Review of Hydrogeological Report on Site D – Milton, Proposed Landfill Region of Halton

Report to

**David Estrin, Barristers and
Solicitors for the Town of Milton**

**FIGURE 6 : EXTENT OF UPPER GRANULAR UNIT
SITE D, MILTON**

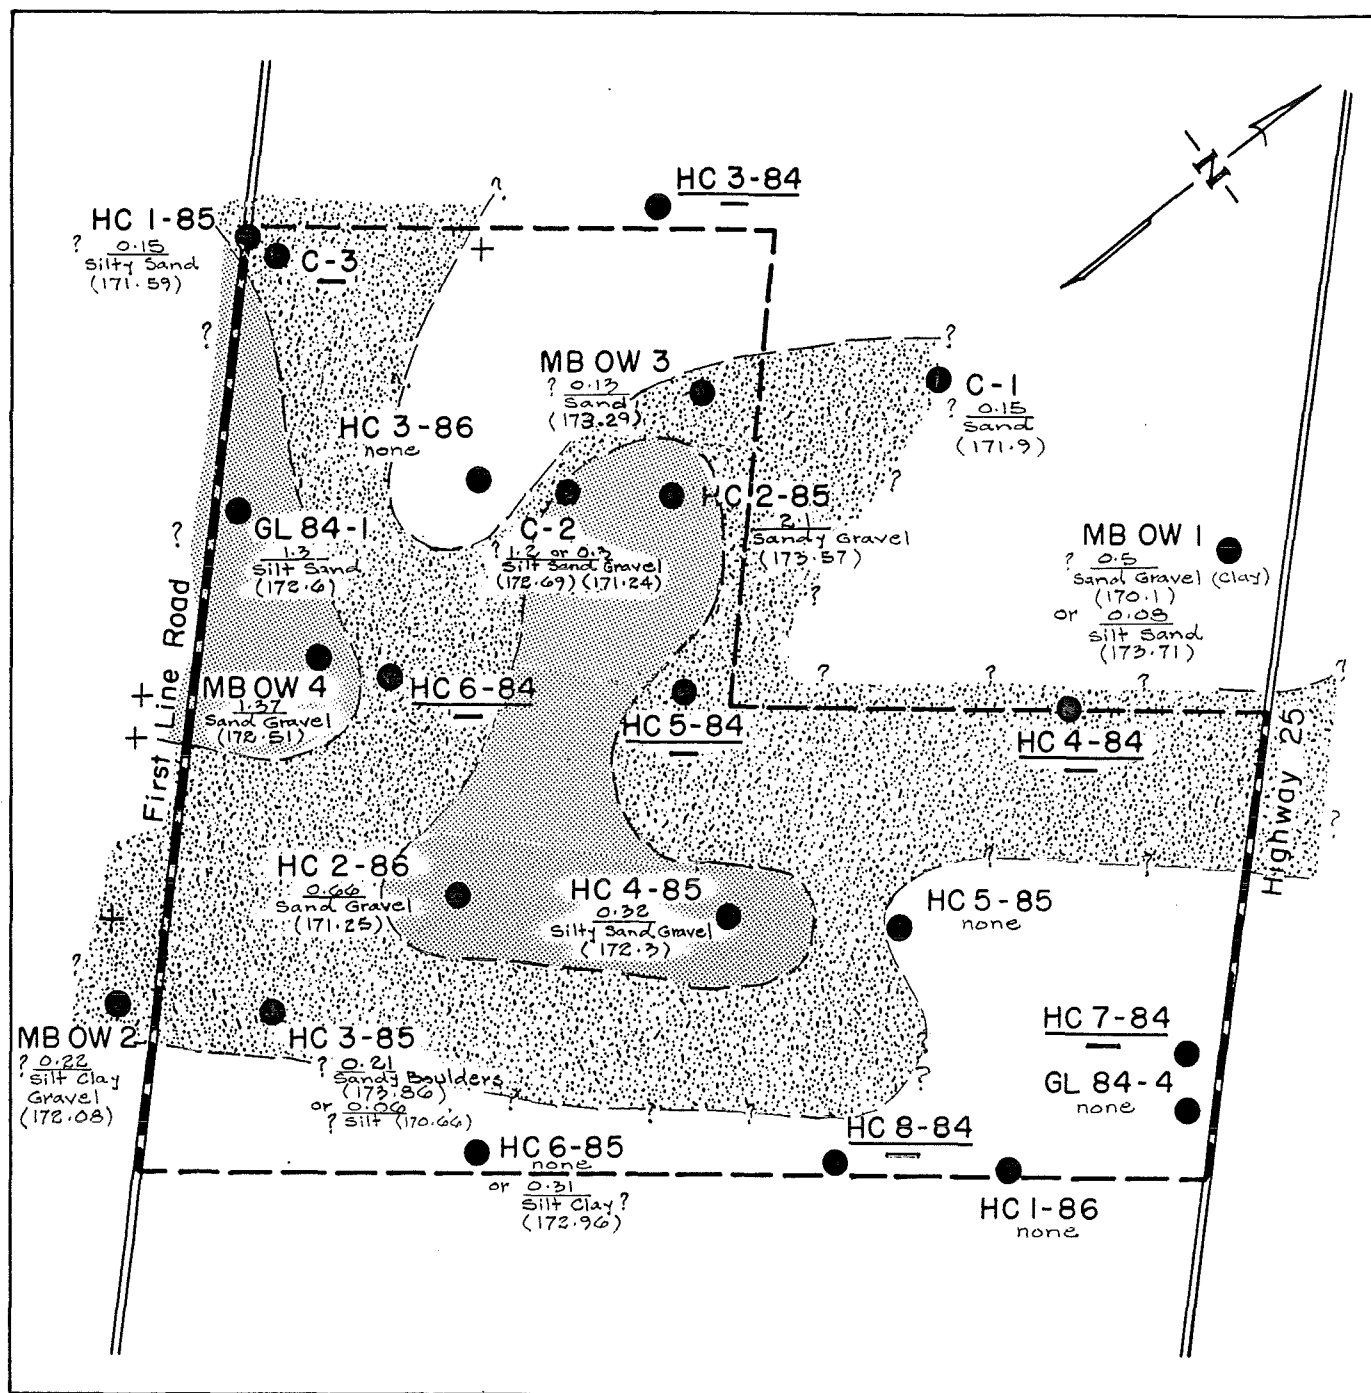
In the Trow report (Ref. 1) the type of uncertainty referred to above is highlighted by an examination of their cross-sections D-D and E-E (Drawings 8 and 9, Vol. 1, ref. 1) in the vicinity of borehole HC5-84, where the cross-sections intersect. On section D-D the Upper Granular Unit is shown as being absent in borehole HC5-84 whereas on section E-E presumably extrapolating from HC4-85, the Upper Granular Unit is shown as being present. As the sampling in the 1984 drilling program was not continuous, but only took place every 1.5 metres, it is possible that the Upper Granular unit was missed in borehole HC5-84 and that section E-E is the more accurate interpretation.

On their section G-G Trow do not show the Upper Granular Unit extending to the northern end of the section. However an examination of the detailed logs for the Comcor (CC-2) and Morrison-Beatty (OW-3) boreholes shows more granular material at an elevation of approximately 170 to 173m which roughly corresponds to the elevation of the Upper Granular Unit. Thus it seems reasonable, and certainly conservative at least from the perspective of potential contaminant migration, to assume that the Upper Granular Unit

FIGURE 7 : EXTENT OF 'SILT' LAYER
SITE D, MILTON

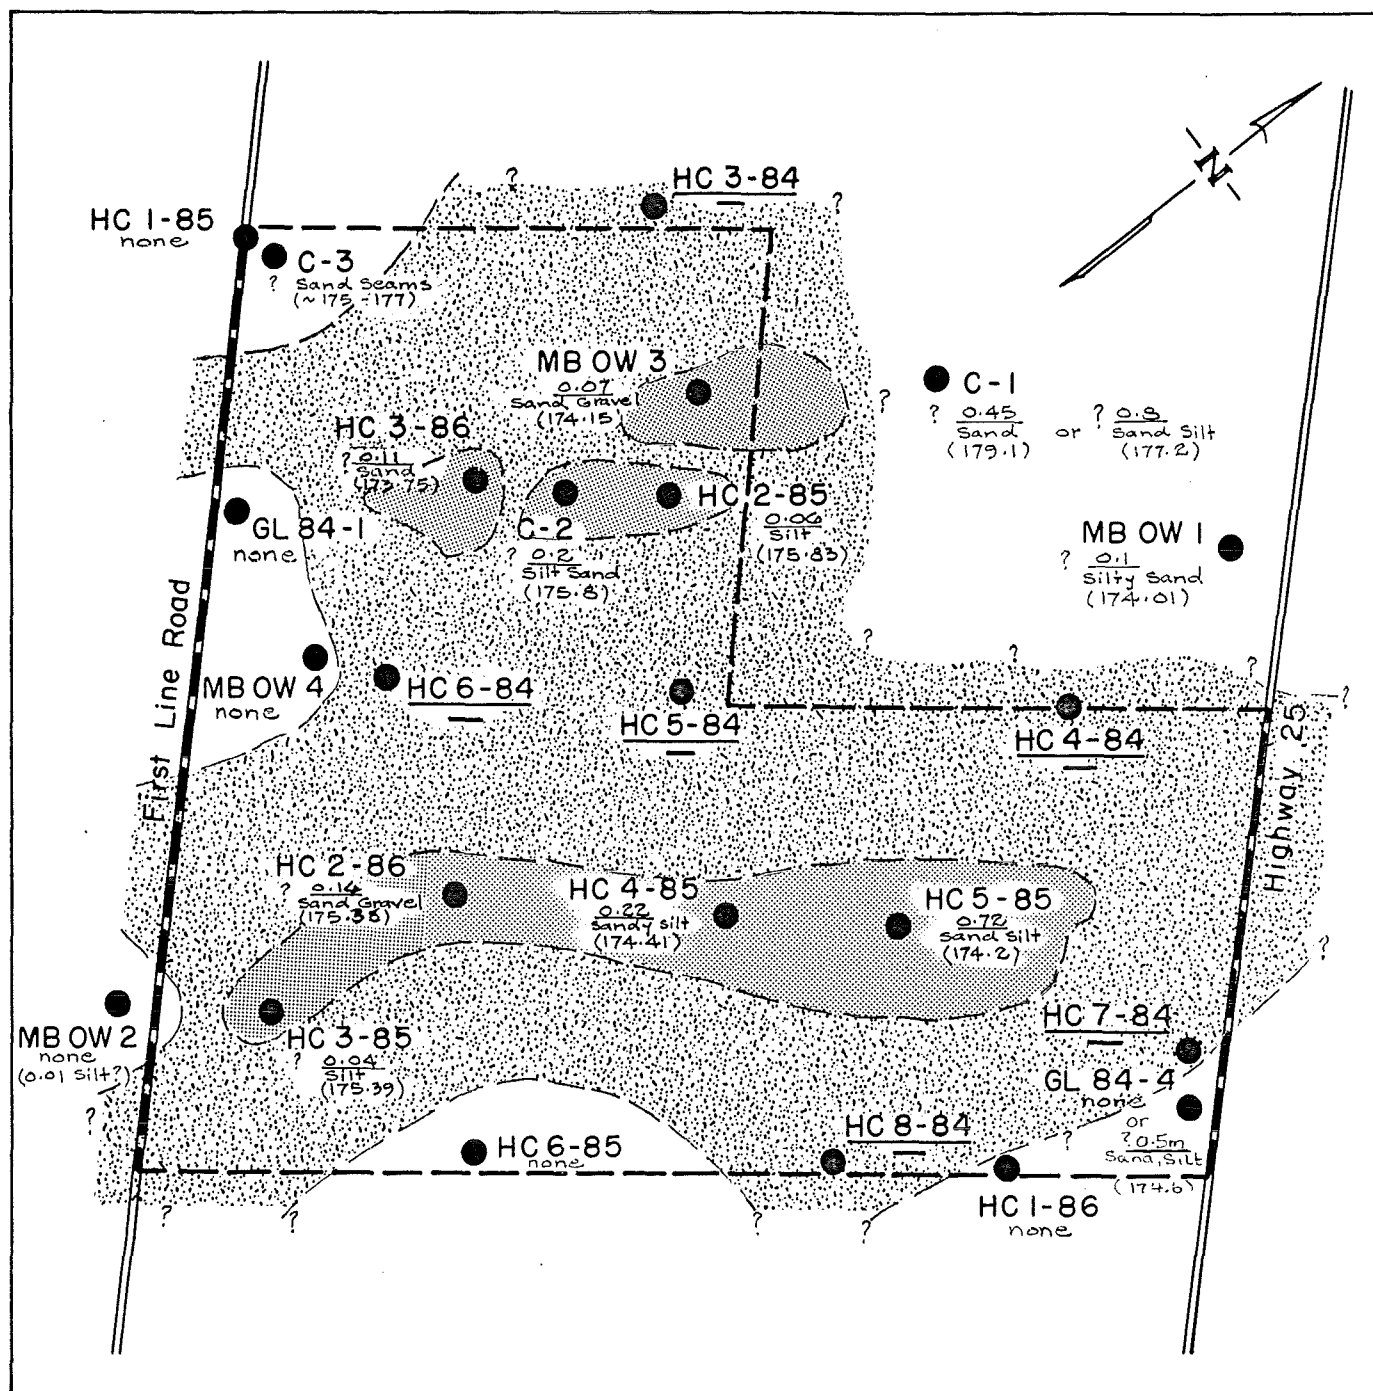
In the case of the unit described by Trow as a "thin bed of silt", Trow did not prepare a plan view of its extent but, from our Figure 7, it can be seen that the most conservative approach (in terms of assessing potential paths for leachate migration) could have it underlying virtually all of the site.

Alternatively it may be of much less significance. Thus, with the present data base, there is a fair degree of uncertainty about the extent of this unit.

With regard to the texture of this so called "thin bed of silt" it can be seen from the data plotted on Figure 7, which is derived from the borehole logs, that the nature and thickness of this deposit varies considerably. For example at HC4-85 the silt layer is represented by 22 cm of sandy silt whereas at nearby HC2-86 there are 16 cm of sand and gravel at a similar elevation. Thus, describing the unit as a silt layer may be somewhat misleading in that such a description can imply less variability than is actually found.

However, as was demonstrated in Section 4, this "thin silt" unit could underlie most of the site and, where encountered, varies in thickness and texture from 4 cm of silt to 16 cm of sand and gravel and 72 cm of sand and silt. Thus, given its relative proximity to the bottom of the landfill (~4m), a conservative approach would consider its hydrostratigraphic significance.

**FIGURE 8 : EXTENT OF LOWER GRANULAR UNIT
SITE D, MILTON**

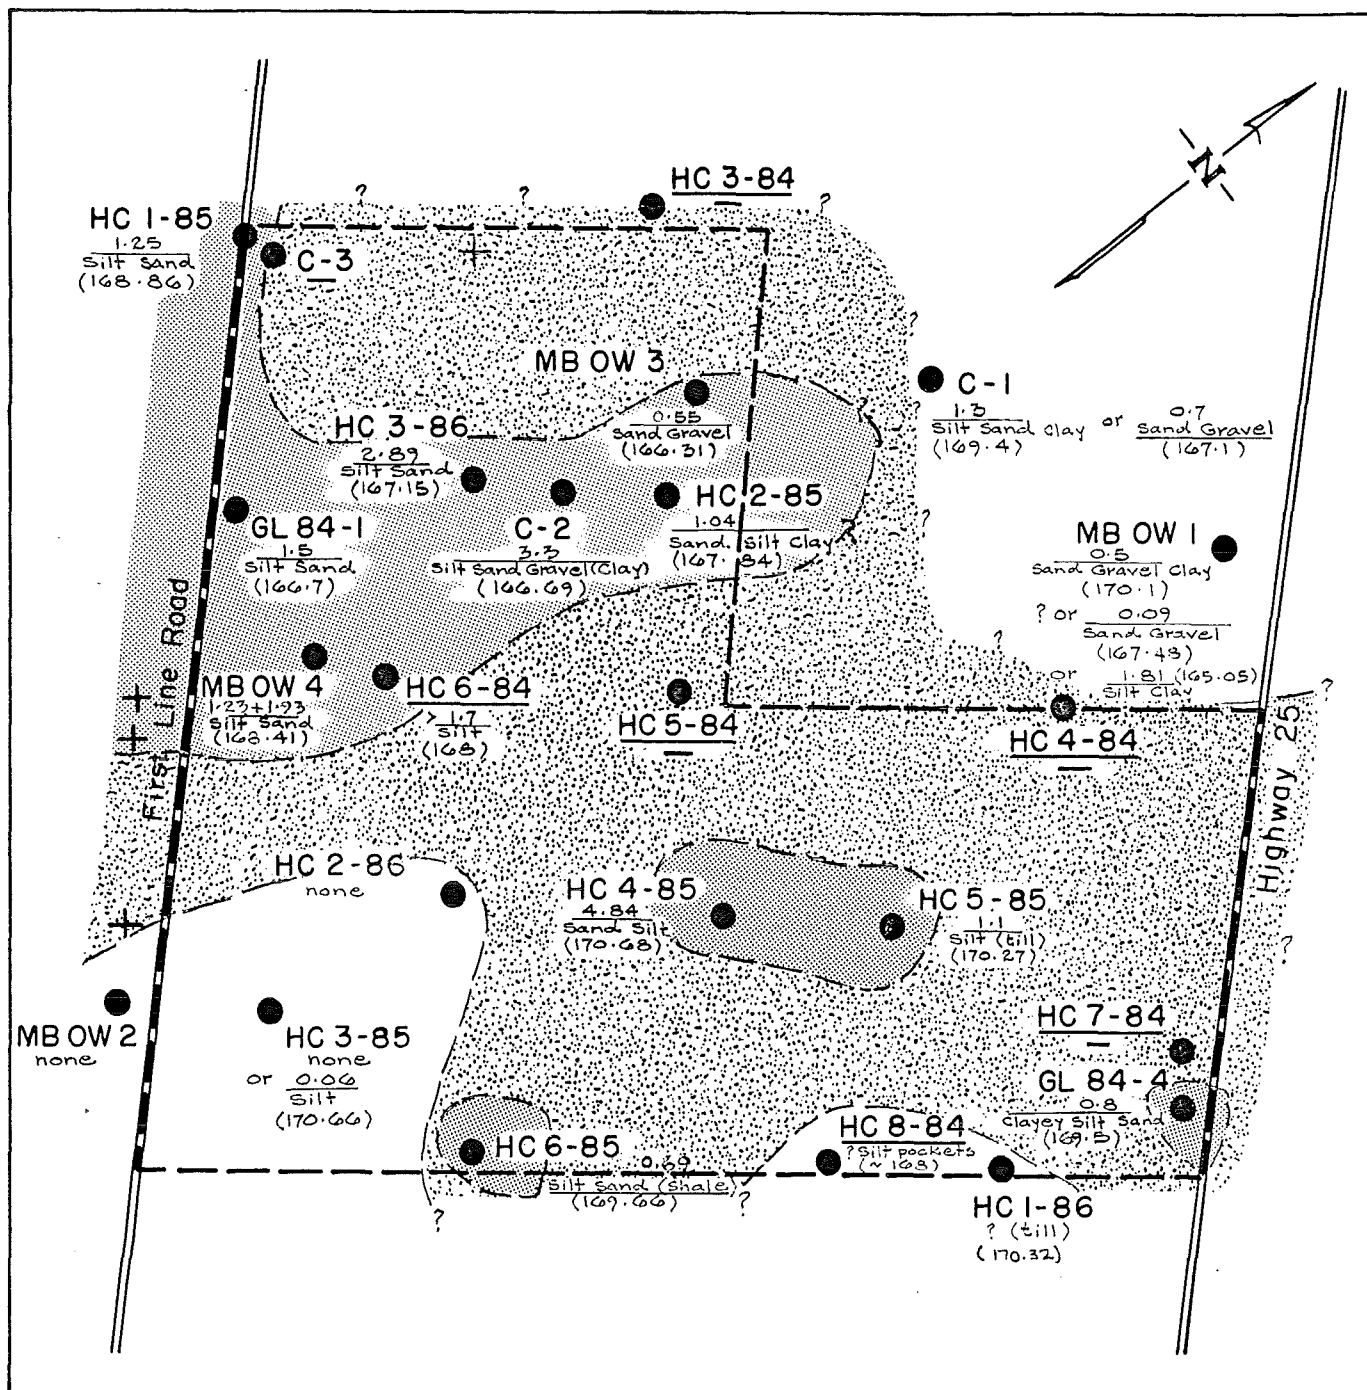
No groundwater contour map was presented for the Lower Granular Unit, presumably due to the paucity of data.

In fact an examination of the data in Appendix 5 reveals that there are no Trow boreholes actually showing a downward gradient from either the Lower Granular Unit or the underlying till into the bedrock. Borehole HC3-85, in which the Lower Granular Unit is absent, does show a downward gradient from the Upper Granular Unit, albeit it a very slight one, and Morrison Beatty MB-OW3 appears to show a downward gradient from the Lower Granular Unit.

Data from the five Trow boreholes which appear to show a downward gradient into the bedrock are actually being measured from some point above the Lower Granular Unit and could thus be misleading. In fact with four boreholes actually showing gradients up from the rock into the overlying surficial deposits (HC1-85, HC4-85, HC1-86 and HC2-86) the evidence to support the bedrock as an underdrain appears to be, at best, tenuous.

The statement on Page 51 that "...an upward gradient of about 0.01 was measured between the gravelly till and the Bedrock at well HC4-85" appears to minimize the significance of the water levels by implying that movement would only be upwards into the base of the till, on a localized scale. However this statement is obviously incorrect. The gradient is upwards from the bedrock into the Lower Granular Unit and hence this gradient is of potentially greater significance, suggesting that the Lower Granular Unit could be acting as the underdrain for the system.
